CITY OF MOBILE
TIGER 2016 Project Phase Four- Dr. Martin Luther King Jr. Ave from NW of Butchers
Lane to Beauregard St
Project No. 2023-2045-01

ADDENDUM #2

This addendum includes the following: (1) revised contract language, (2) revised PROPOSAL form (Attachment "A"), (3) responses to remaining questions and (4) updated plan sheets (Attachment "C"). This addendum consists of a total of 93 pages, including the cover page.

SUMMARY OF PLAN SHEET CHANGES

REFERENCE PROJECT NO	FISCAL YEAR	SHEET NO
2023-2045-01 TIGER-FAUP-4917(250)	2025	406

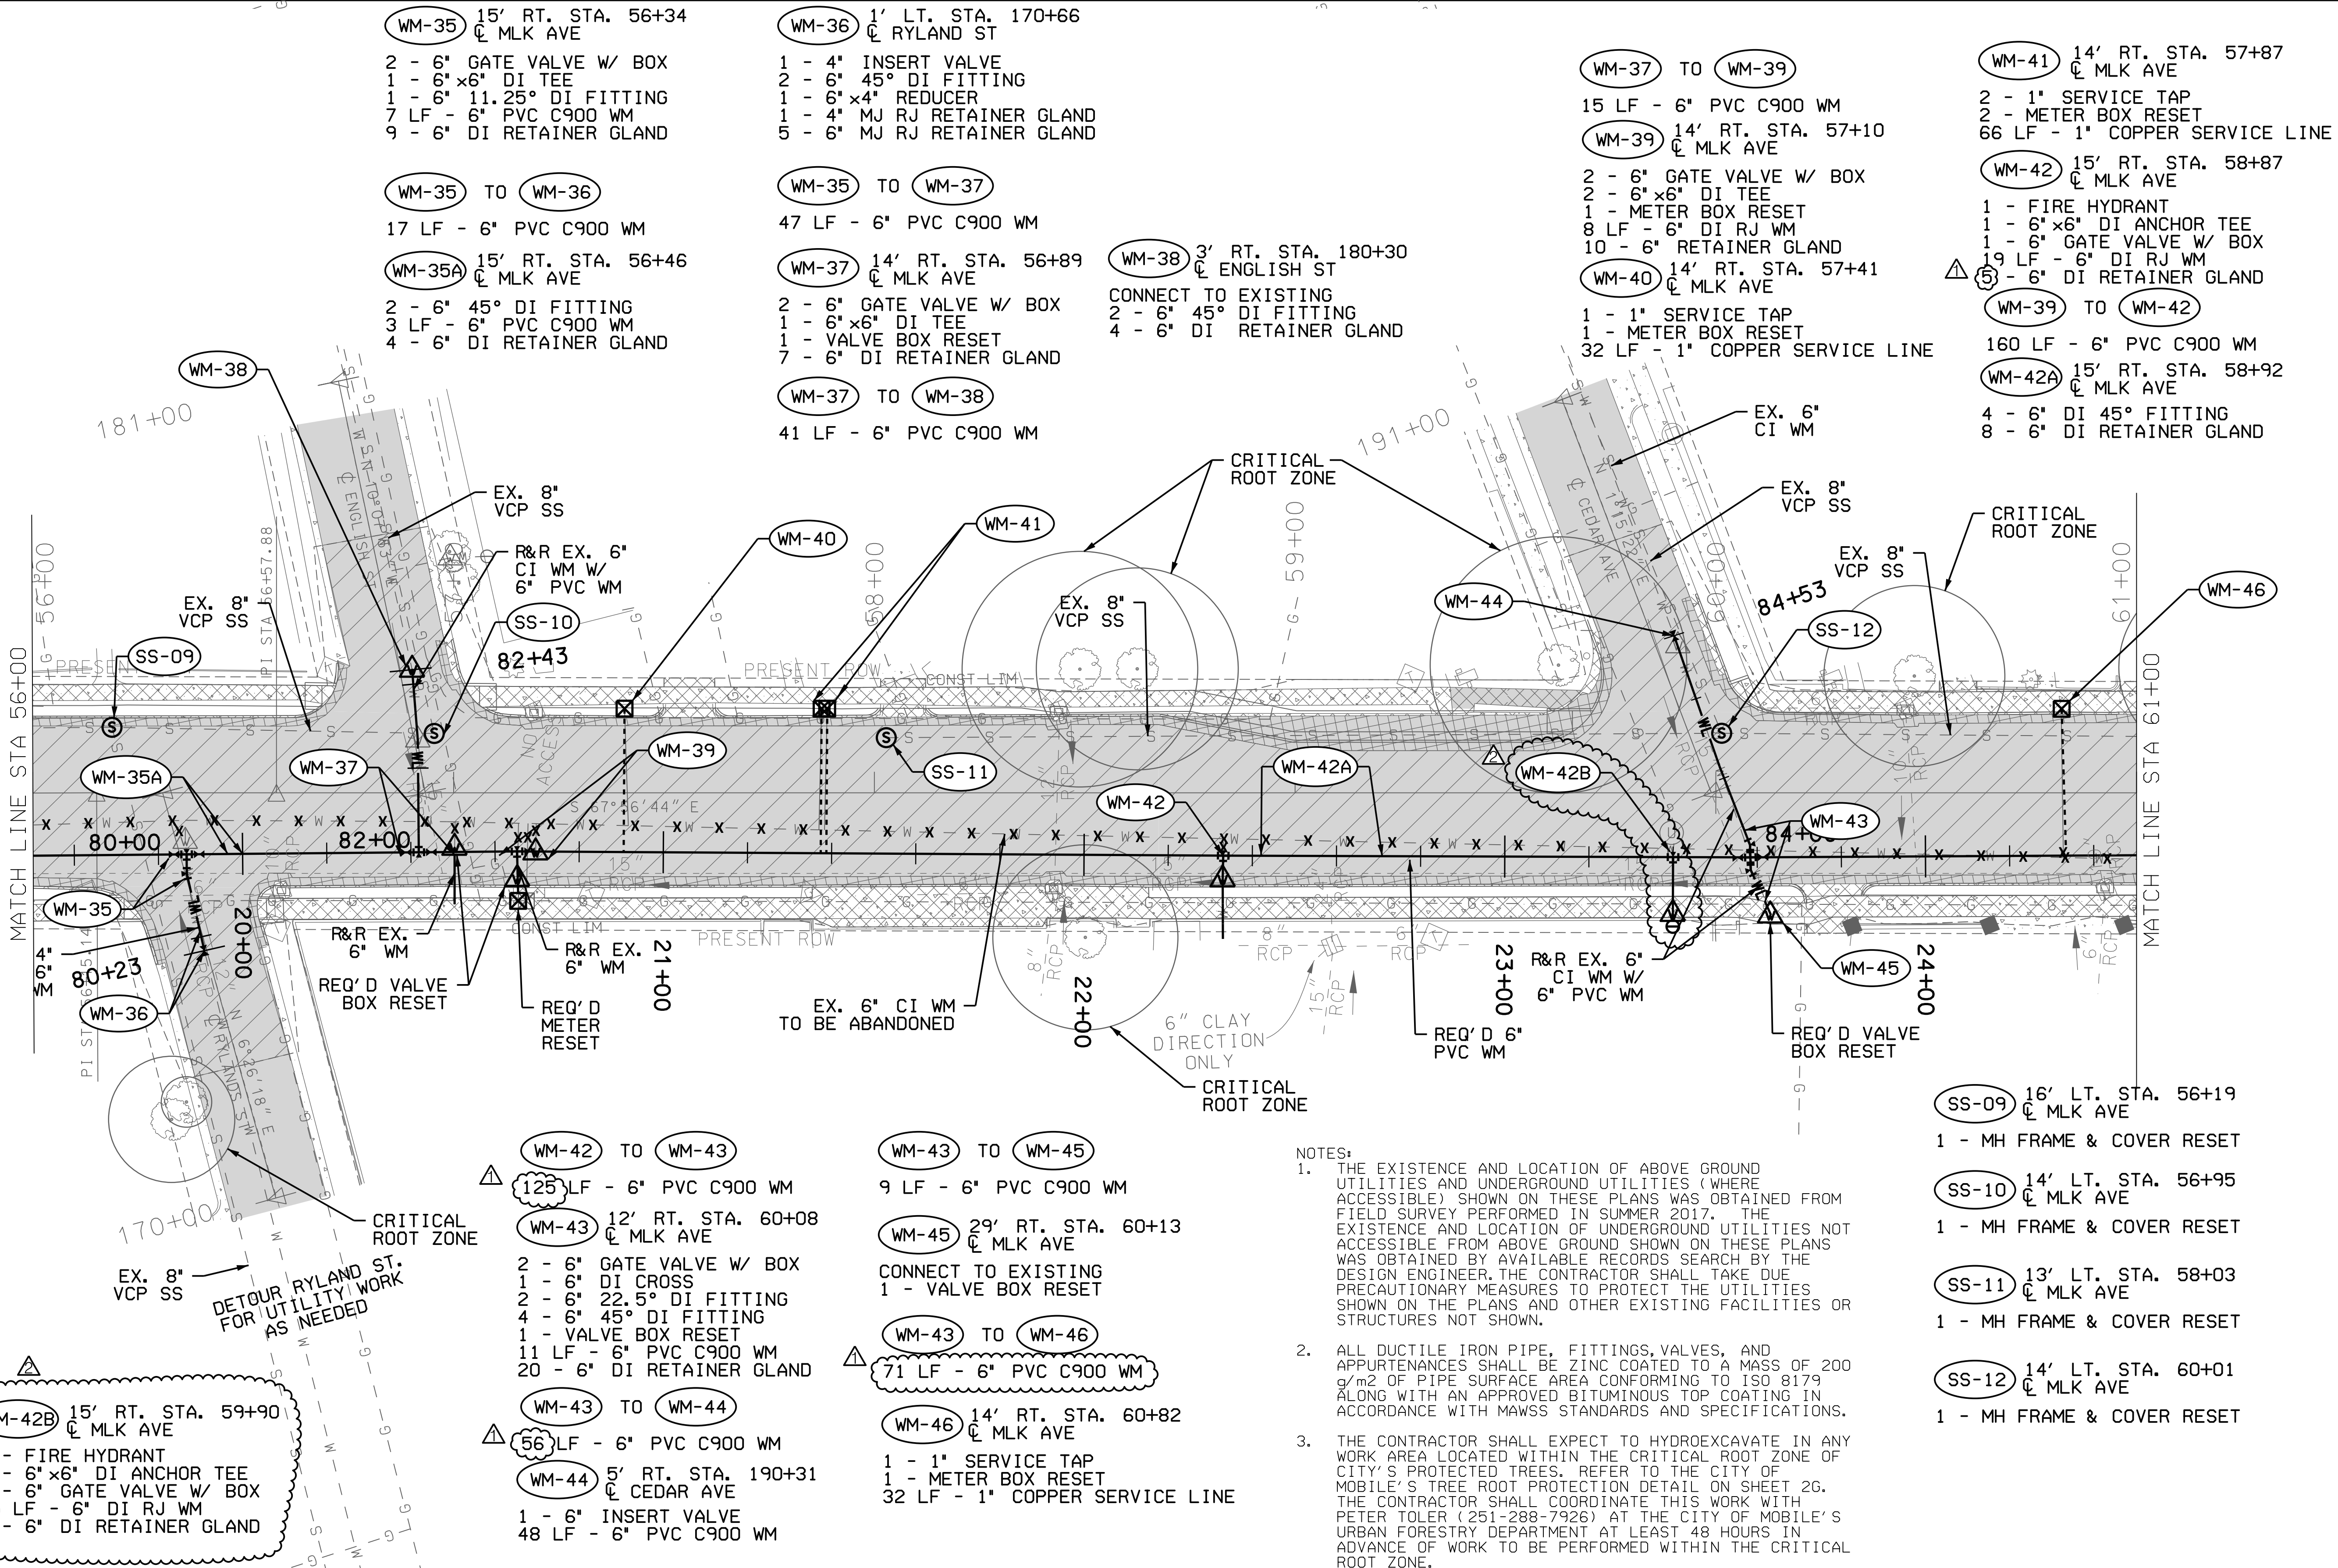
- **SHEET 405**
 - Callout WM-26 – Added 1 6" 11.25° fitting and revised retainer gland quantities
- **SHEET 406**
 - Callout WM-42 – Revised retainer gland quantity

- Callout WM-42 to WM-43 – Revised pipe length
 - Callout WM-43 to WM-44 – Revised pipe length quantity
 - Callout WM-43 to WM-46 – Removed service tap, meter box reset and copper service line.

- Added the following as Callout **WM-42B**
 - 1 – Fire Hydrant
 - 1 – 6"x6" DI Anchor Tee
 - 1 – 6" Gate Valve W/ Box
 - 15 LF – 6" DI RJ WM
 - 5 – 6" DI Retainer Glands

REFERENCE PROJECT NO	FISCAL YEAR	SHEET NO
2023-2045-01 TIGER-FAUP-4917(250)	2025	406A

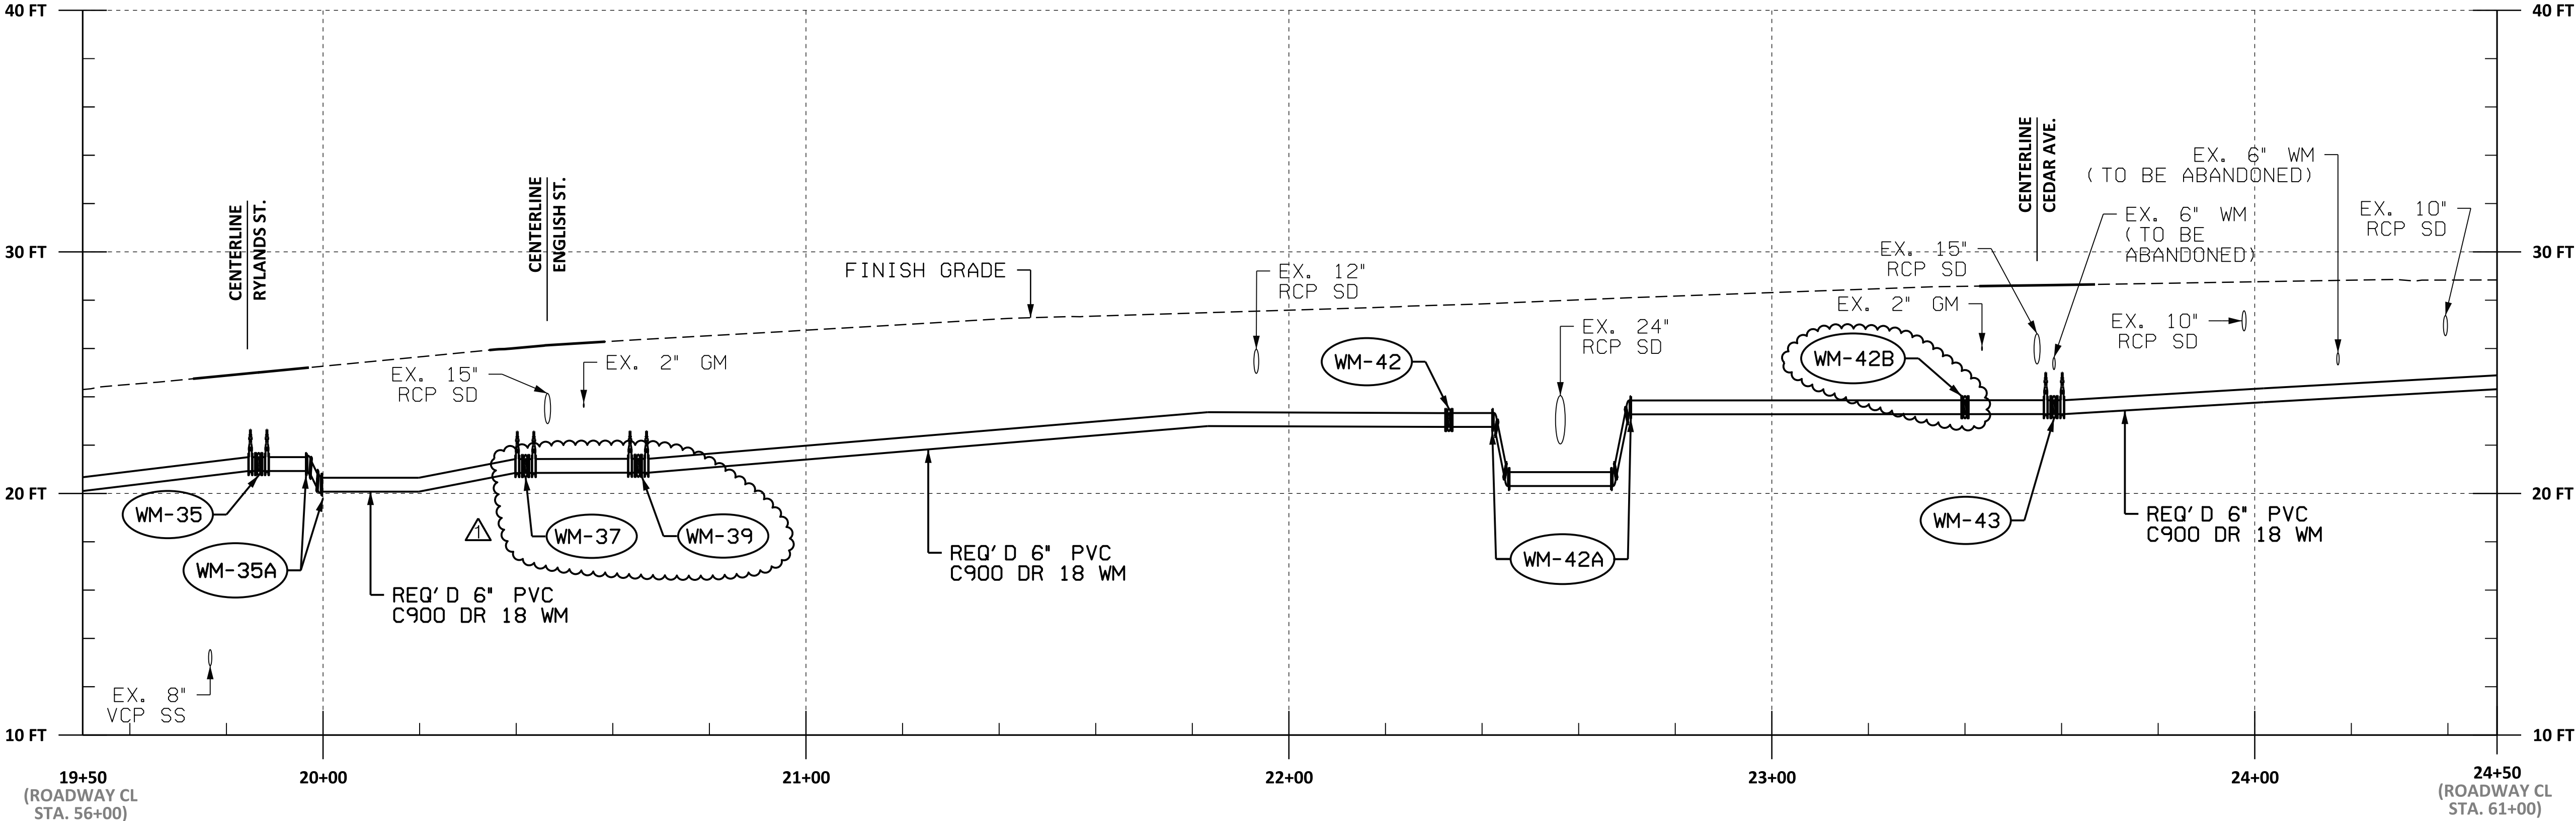
- Callouts WM-37 and WM-39 – Modified leader arrows
- Added symbology and Callout **WM-42B** to profile
- **SHEET 407**
 - Callout WM-47 to WM-49 – Revised pipe length quantity

REFERENCE PROJECT NO	FISCAL YEAR	SHEET NO
2023-2045-01 TIGER-FAUP-4917(250)	2025	407

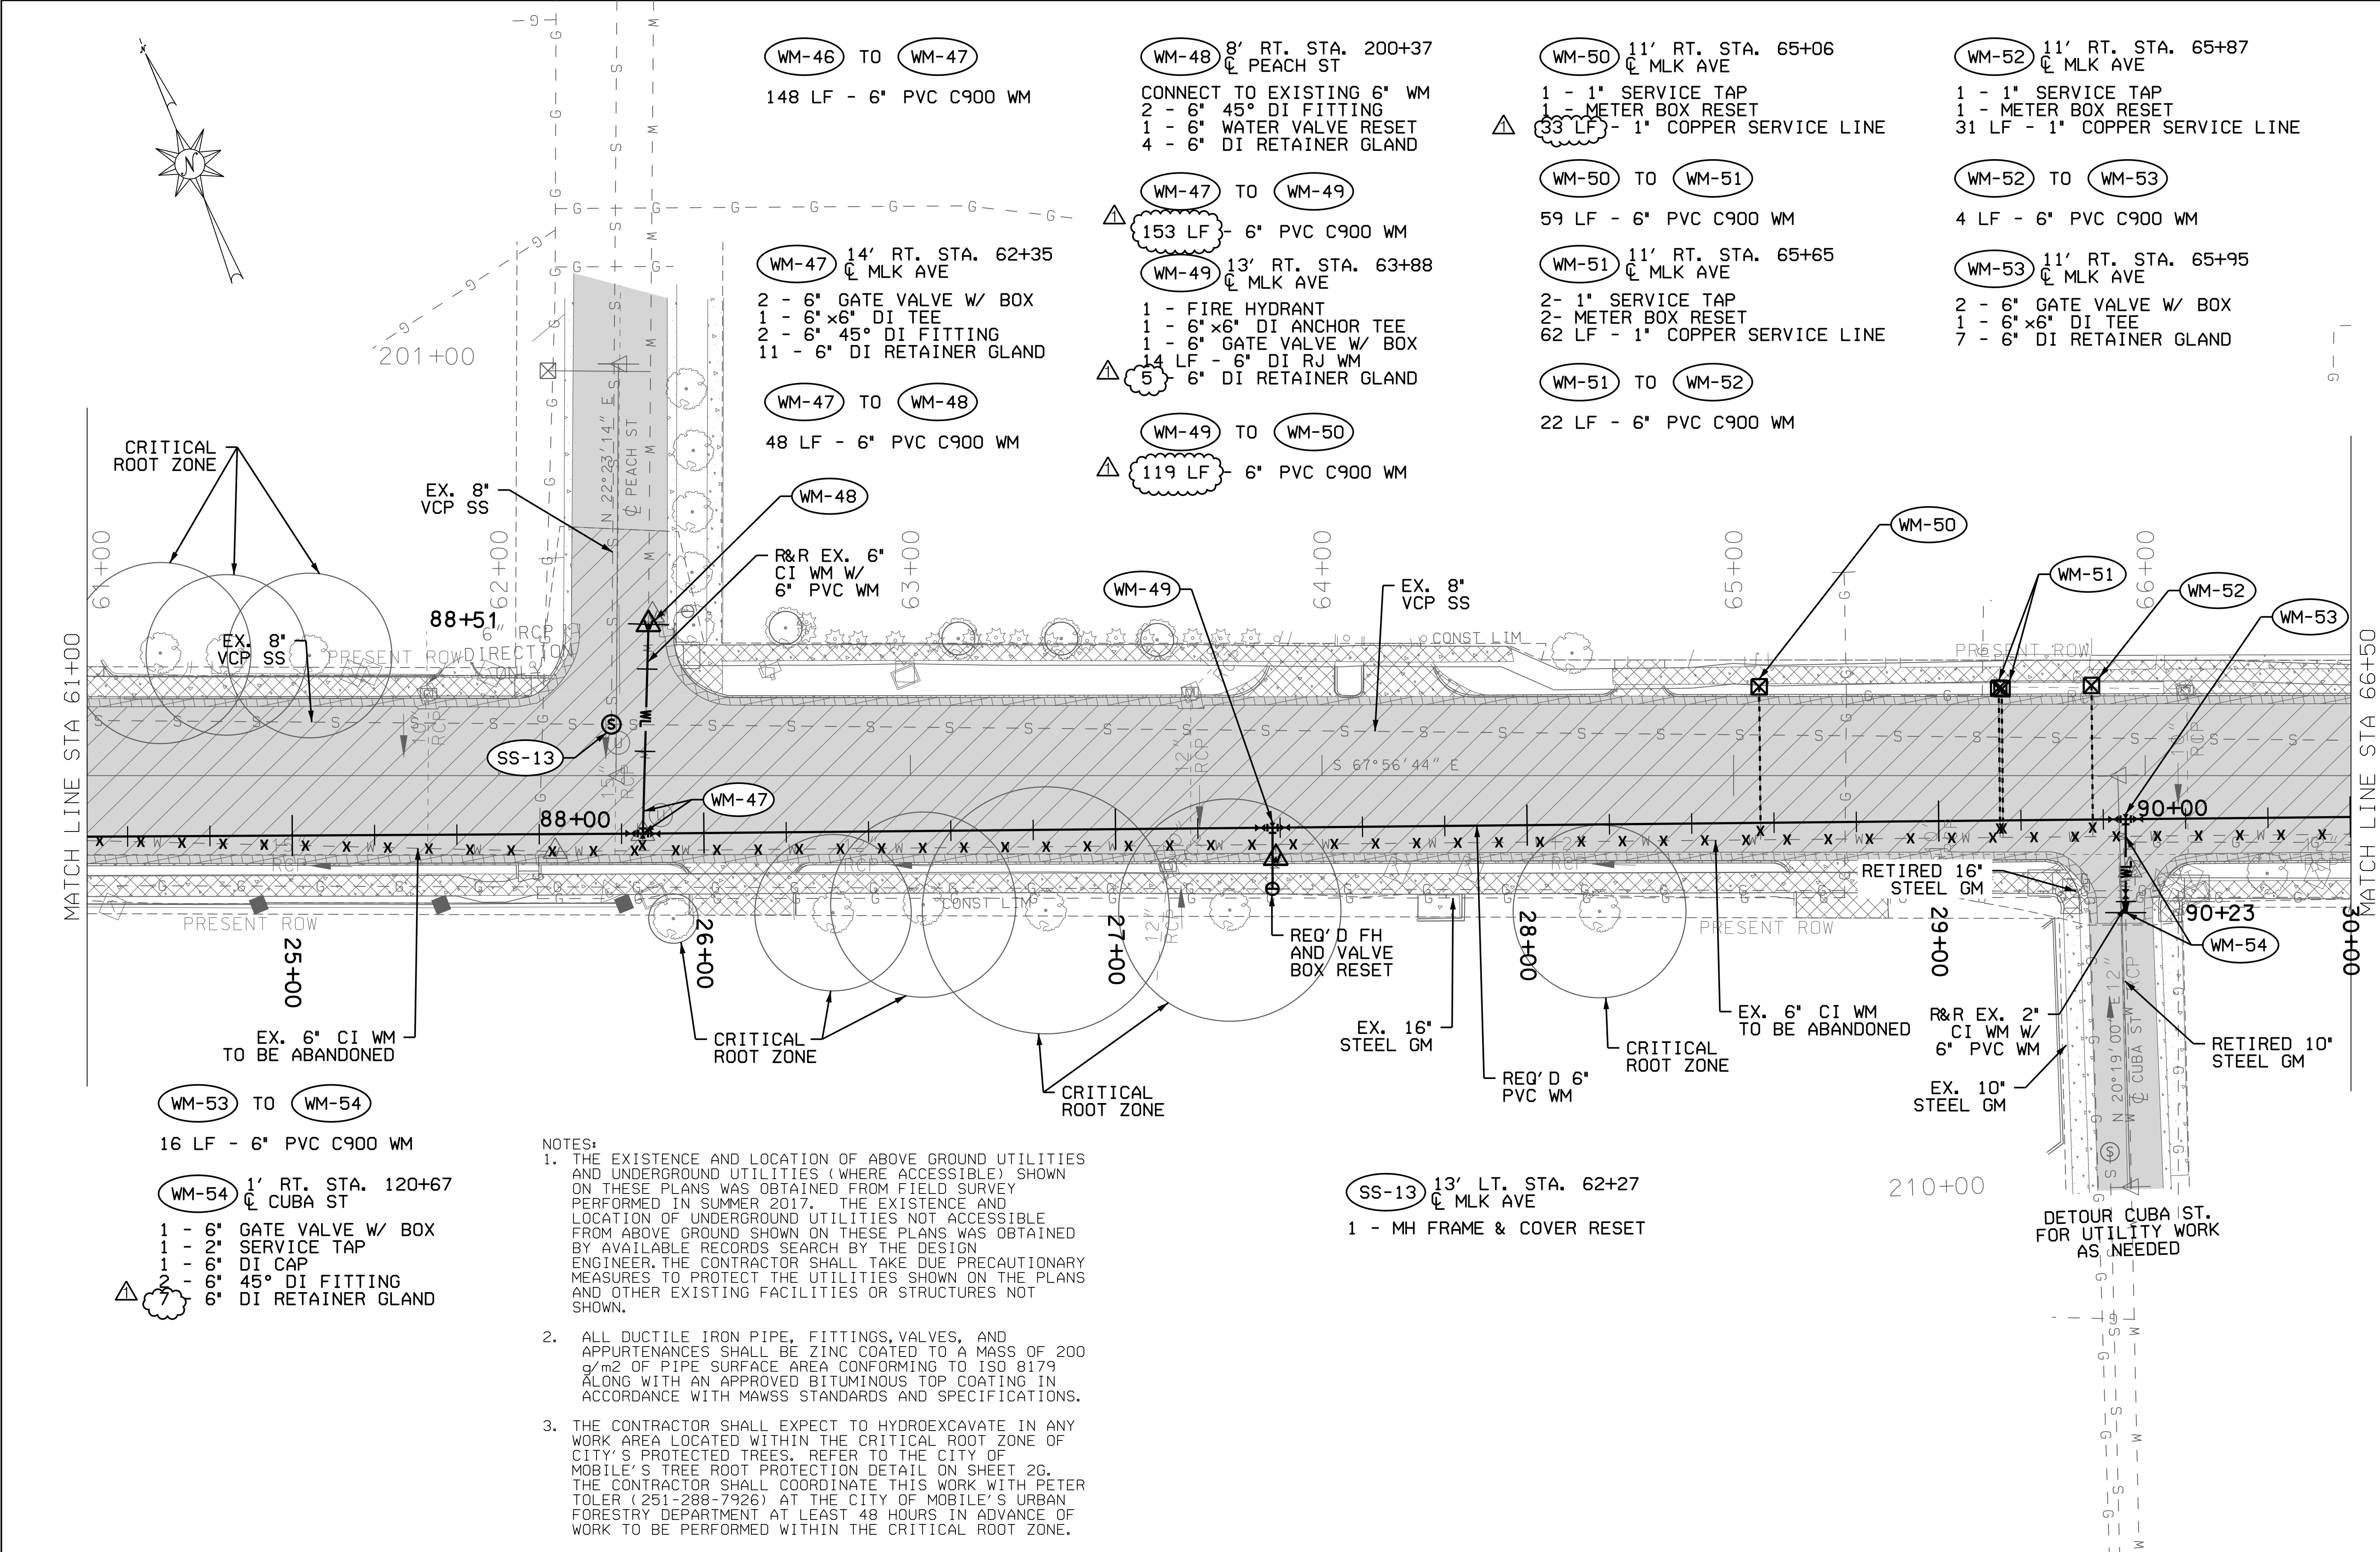
- Callout WM-49 - Revised retainer gland quantity
 - Callout WM-49 to WM-50 – Revised pipe length quantity
 - Callout WM-50 – Revised copper service line length

- Callout WM-54 – Revised retainer gland quantity
- **SHEET 408**
 - Callout WM-53 to WM-55 – Revised pipe length quantity
 - Callout WM-55 to WM-56 – Revised pipe length quantity
